TIGER COMMISSARY

RE: Project # 118641 PD# 22-0368
Tiger Commissary
2508 W Washington Avenue
Jonesboro, AR

Project Comments and / or Needed Corrections

Project Name: Tiger Commissary

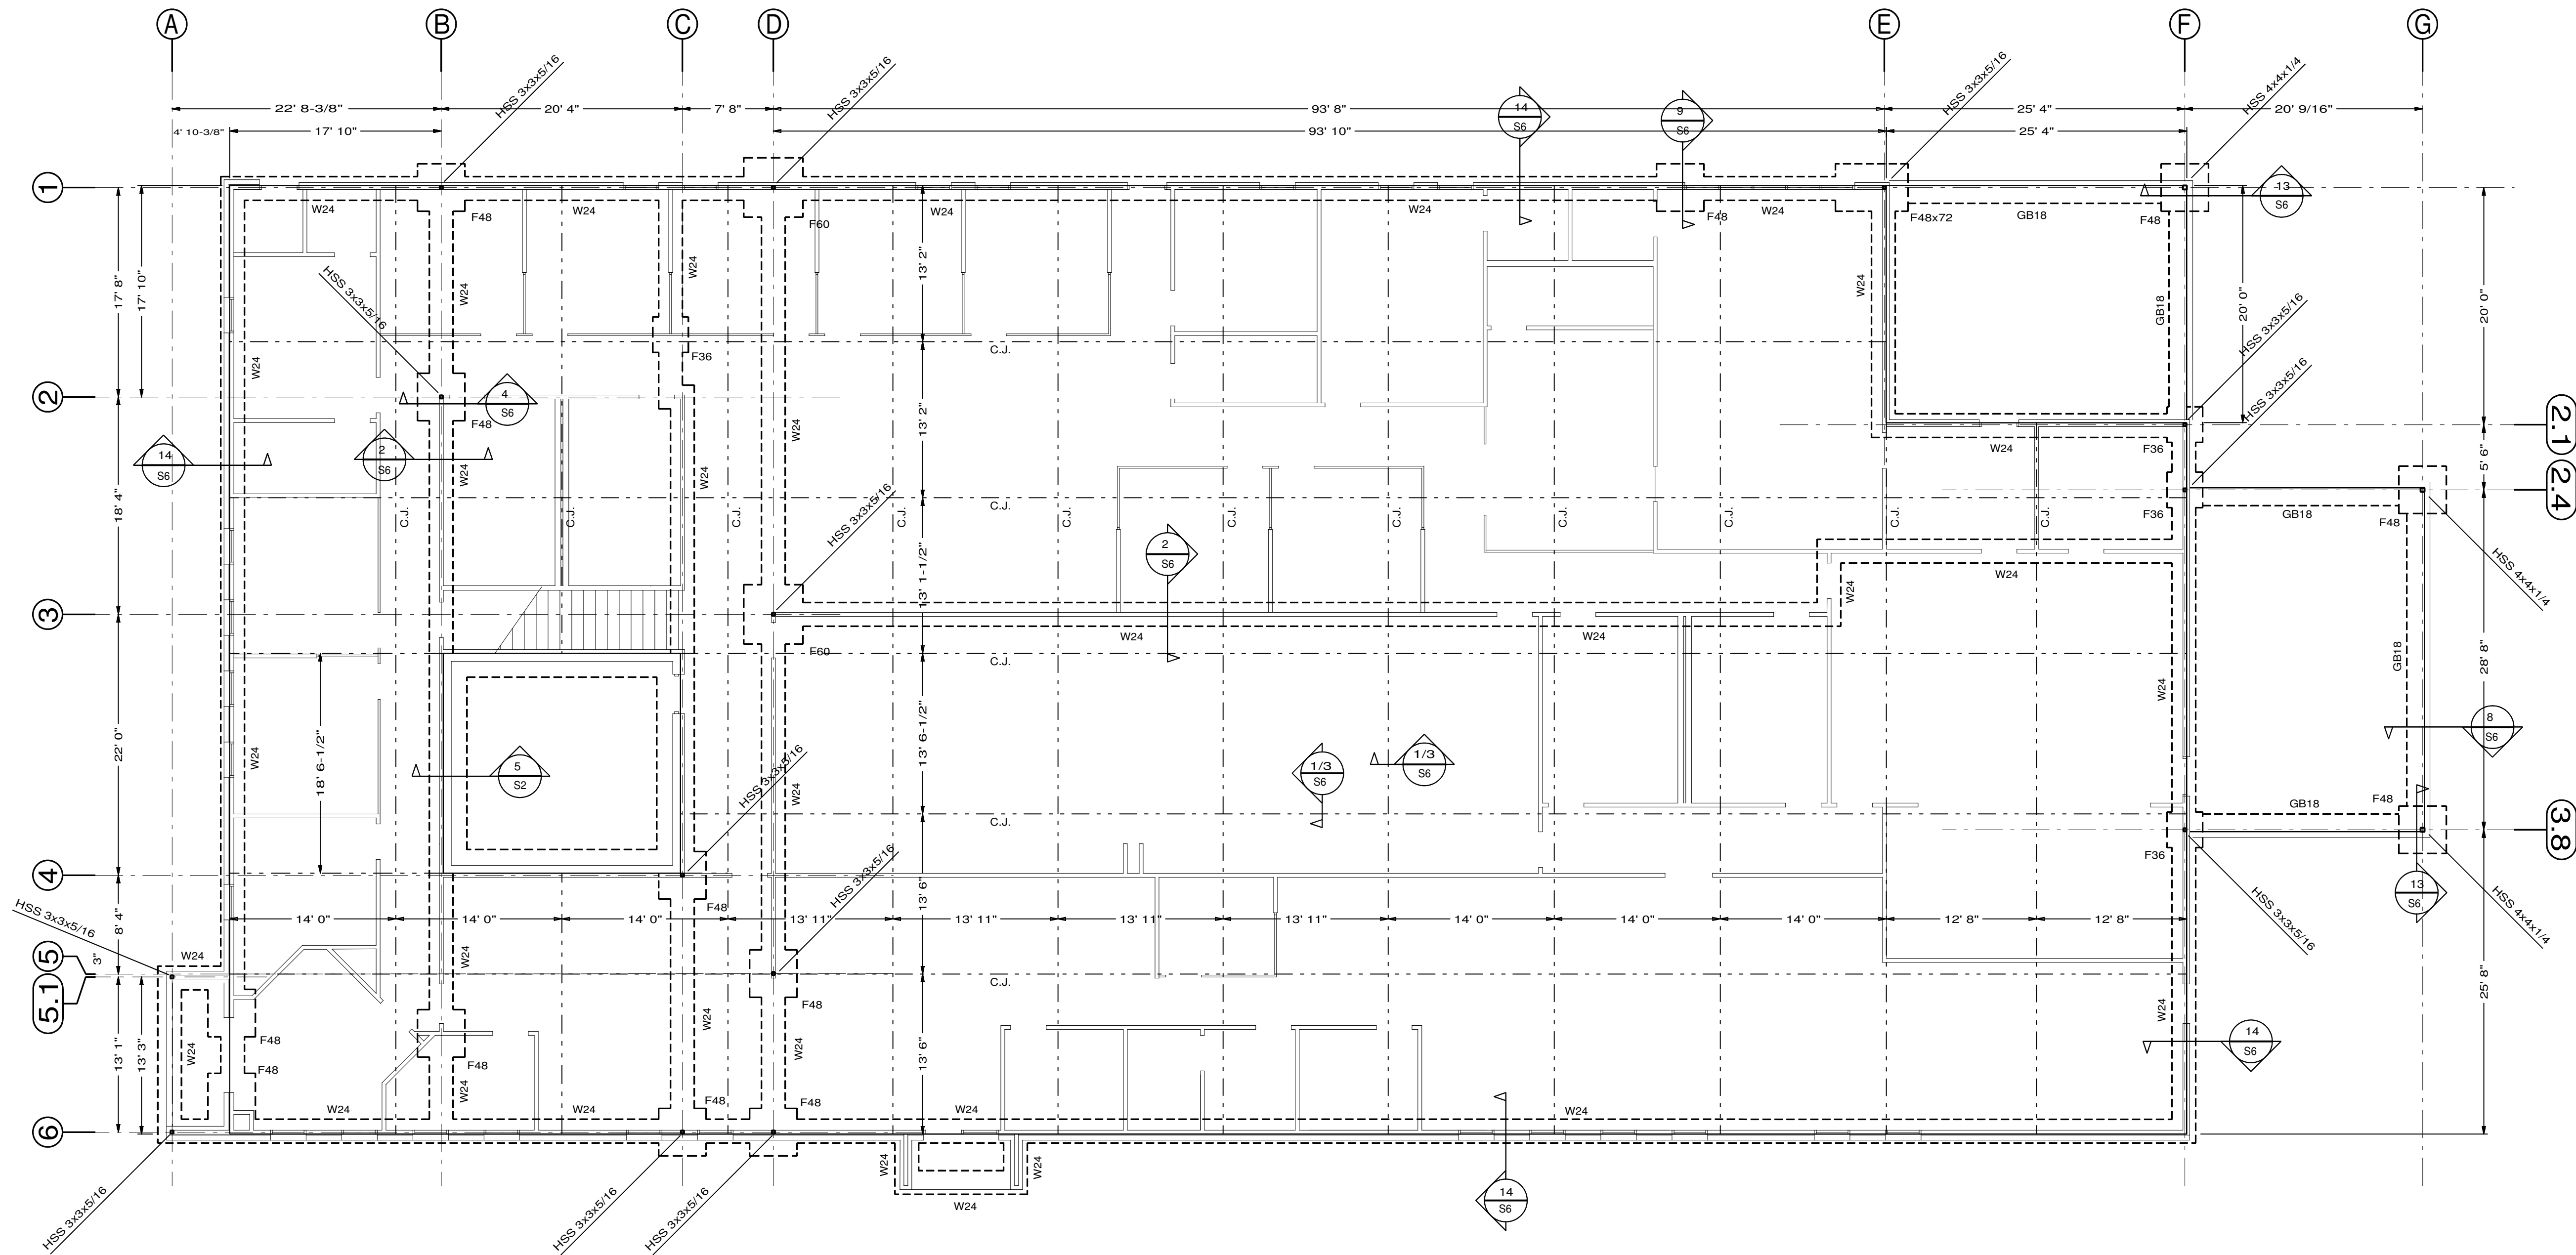
1. **ASPC 901.2.1 Venting required.** Traps and trapped fixtures shall be vented in accordance with one of the venting methods specified in this chapter.
2. **ASPC 802.1 Where required.** Food-handling equipment, dishwashing machines and dishwashing sinks shall discharge through an indirect waste pipe by means of an air gap as specified in Sections 802.1.1 through 802.1.8. (**3-Compartment Sink**)
